**Permit Application Review Report**  
**Date: 1/8/2025**

**Project Name:** Andover Senior Campus

**Project PAN:** P-24-045

**Project Purpose:** development of a 15-acre parcel in Andover to include senior living buildings, future brownstone and townhome buildings, and commercial buildings – This review applies to the construction of phase 1 and approval of a stormwater master plan

Figure 2: Site Plan

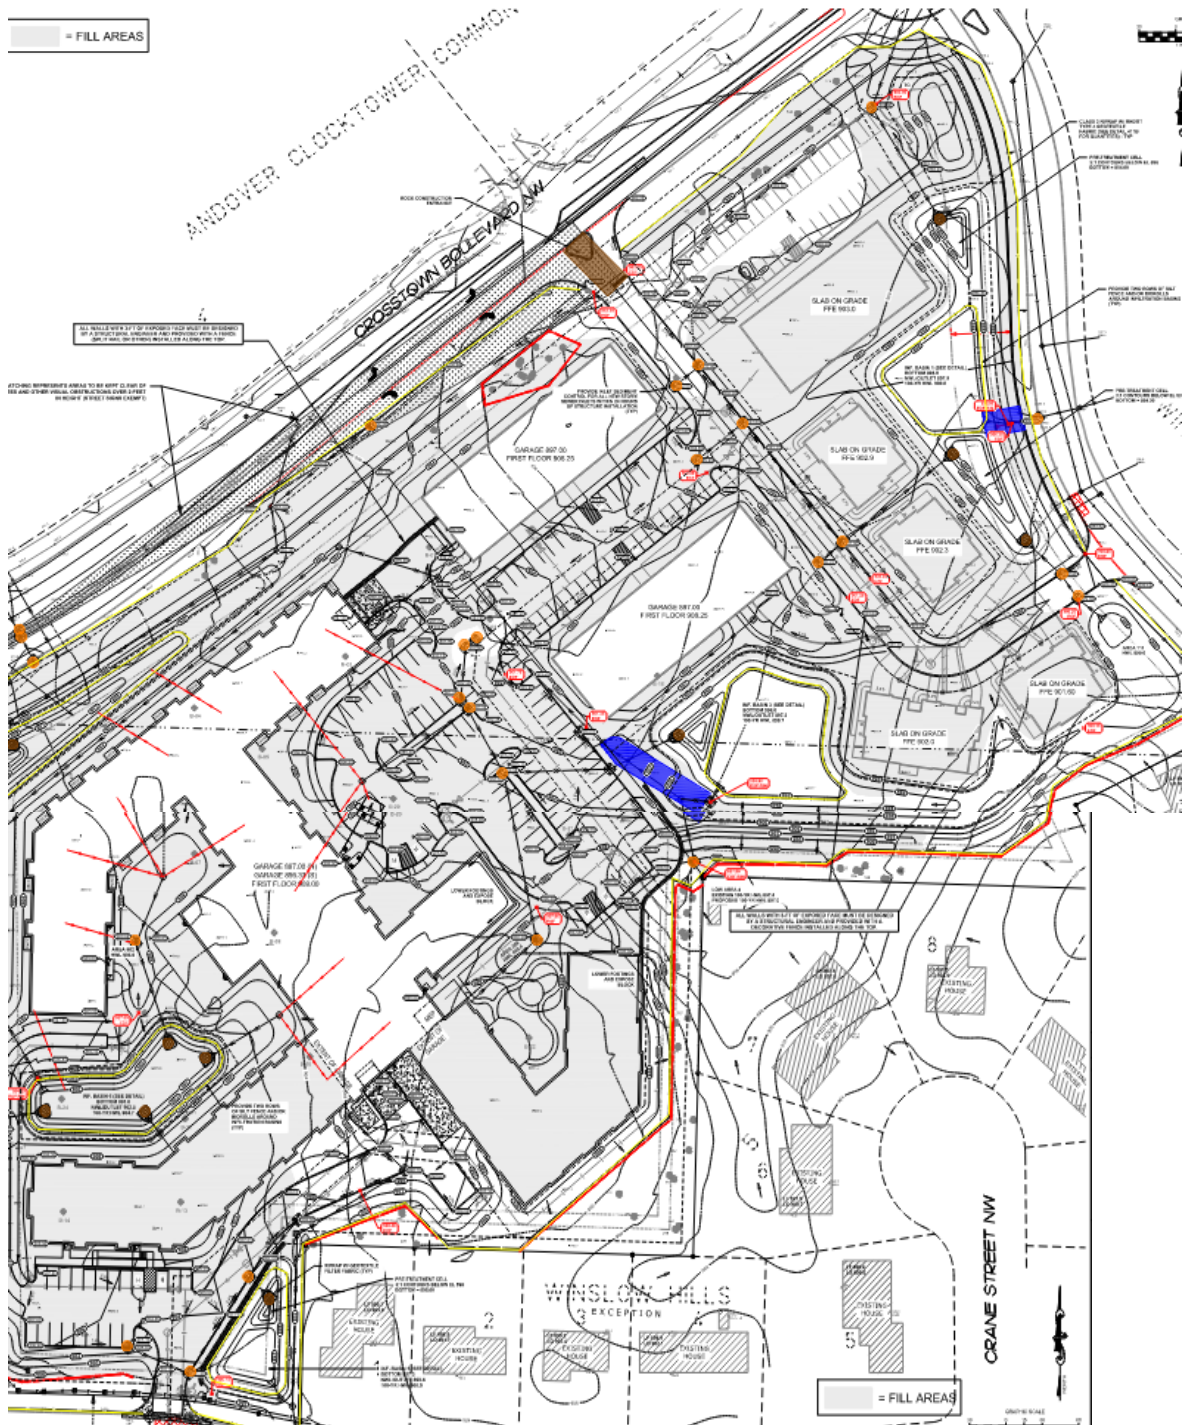
**Description:** The application proposes the development of a 15-acre parcel in Andover to include senior living buildings, future brownstone and townhome buildings, and commercial buildings. It'll include parking, utilities, and stormwater treatment features. This phase of the project will only include the construction of Phase 1 and an overall stormwater master plan. The total project will disturb 13.7 acres and create 6.74 acres of new/regulated impervious. The parcel drains to County Ditch 57. The relevant Water resource concerns are stormwater treatment and erosion and sediment control. These correspond to District Rules 3 and 4. See attached Figure 1: Project Location and Figure 2: Site Plan.
